PROPOSAL FOR DRAFT AMENDMENTS TO REGULATION No. 113

(Headlamps emitting a symmetrical passing beam)

The text reproduced below was prepared by the expert from Germany in order to clarify and update the provisions in the proposed amendments in document ECE/TRANS/WP.29/GRE/2009/27 of headlamps for the approval test procedure. This is a proposal for correction of the existing Regulation as well as of document ECE/TRANS/WP.29/GRE/2009/27.

Figure A

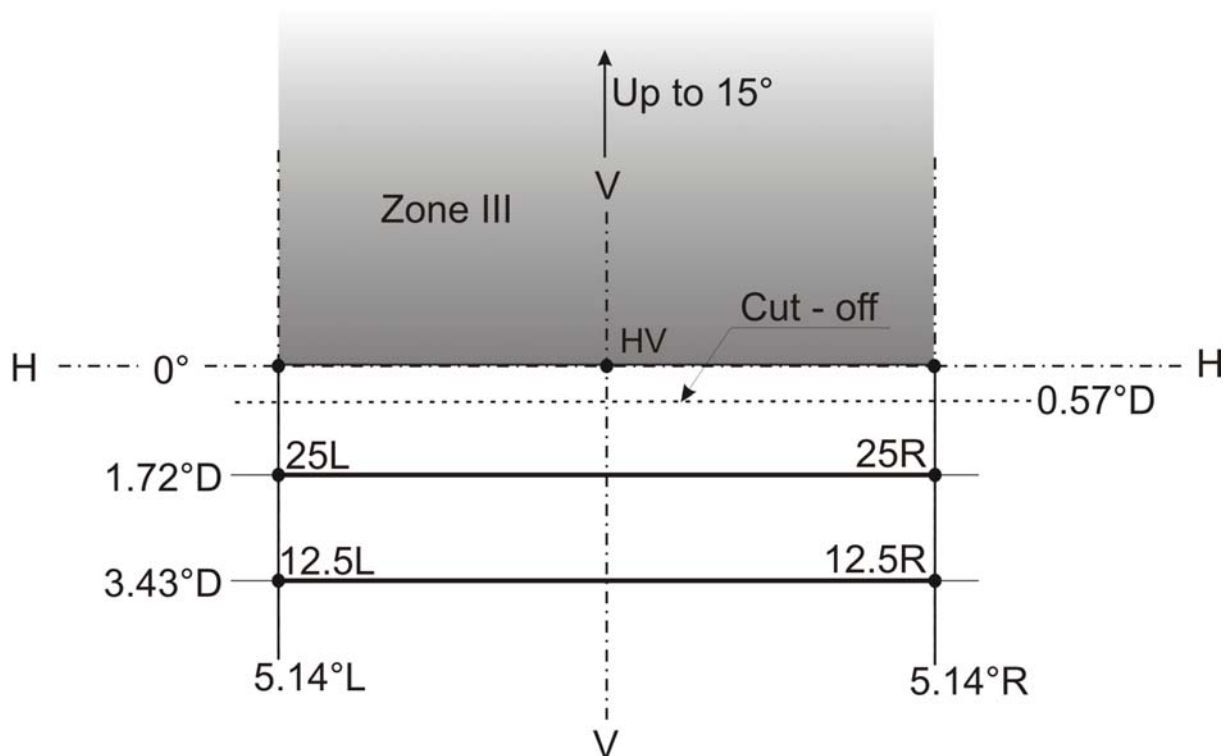
Amend the drawings for Class A and Class B Headlamps:

MEASURING SCREEN
for Class A headlamps
(Dimensions in mm with screen at 25 m distance)

Figure B

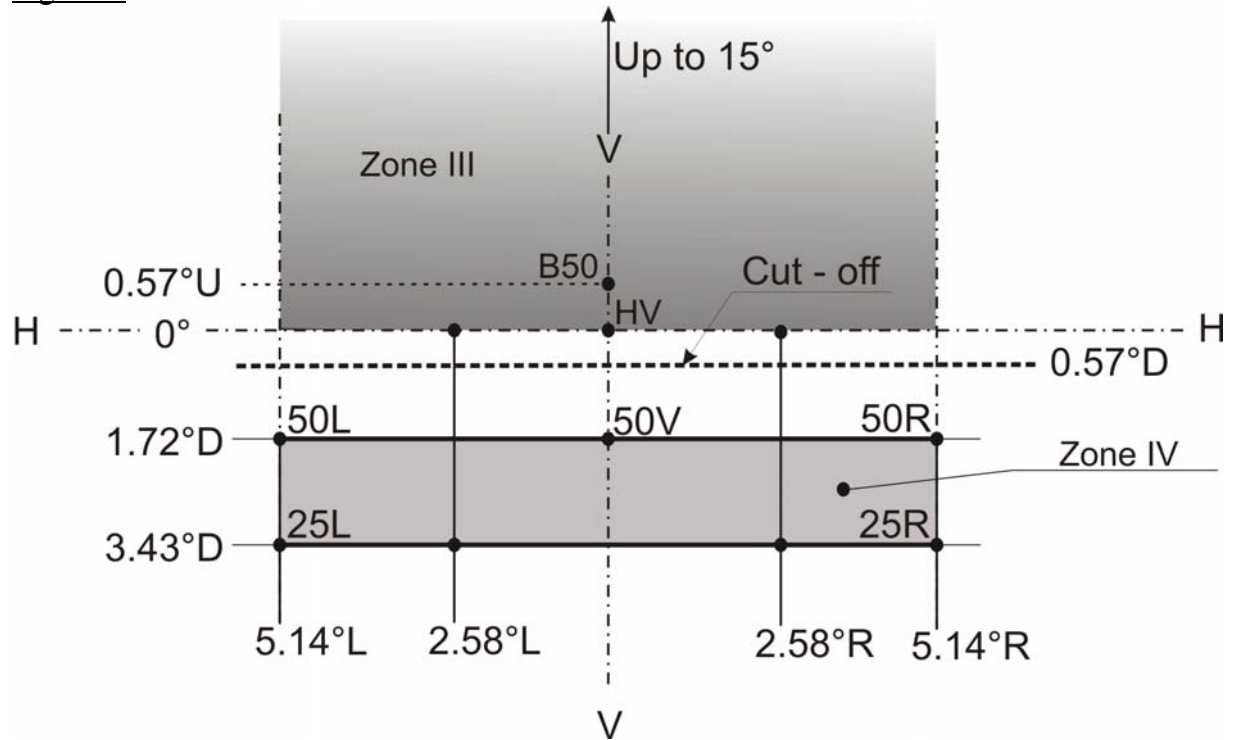
MEASURING SCREEN
for Class B headlamps
(Dimensions in mm with screen at 25 m distance)

In the light distribution of the Class B headlamps were been also referenced the Zone I and the Zone II without any application of this Zones inside the Regulation, therefore this Zones are not more indicated in the drawing. In the CoP requirements. For Class B headlamps was also specified the point B50 without any specification of the coordinates, this mistake is also solved by the introduction in the table because it is still part of the Zone above the hh-line (Zone III).
